CAA Operational Assessment

Title of airspace change proposal	Aberdeen International Airport Airspace Change Proposal (ACP)
Change sponsor	Aberdeen International Airport Ltd (EGPD)
Project reference	ACP-2019-082
Account Manager	[REDACTED]
Case study commencement date	2 Jan 25
Case study report as at	6 Aug 25
<i>Instructions</i> In providing a response for each question, please ensure that the 'status' column is completed using the following options: • YES • NO • PARTIALLY • N/A To aid the SARG Lead it may be useful that each question is also highlighted accordingly to illustrate what is: resolved YES not resolved PARTIALLY not compliant NO

Figure 6: Class D Airspace Chart with proposed CAS change (Source: Stage 3 consultation document)

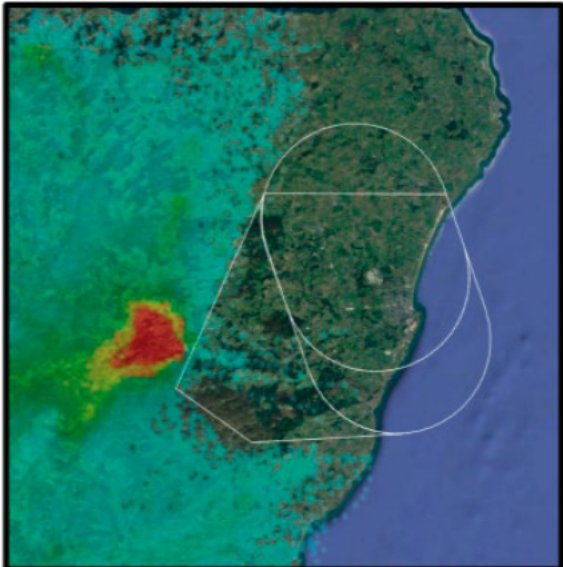
The proposal to reclassify a section of CTA3 from Class D to Class G (*dimensions indicated in adjacent figure: ABZ Stage 4 ACP Submission V1.0, Figure 6, p24*) is supported by stakeholder engagement and evidence demonstrating limited utilisation of the affected airspace by Aberdeen inbound/outbound traffic. The change is expected to improve access for General Aviation users, particularly glider operations in the vicinity of Aboyne, whilst also providing the potential for a reduction in airspace infringements.
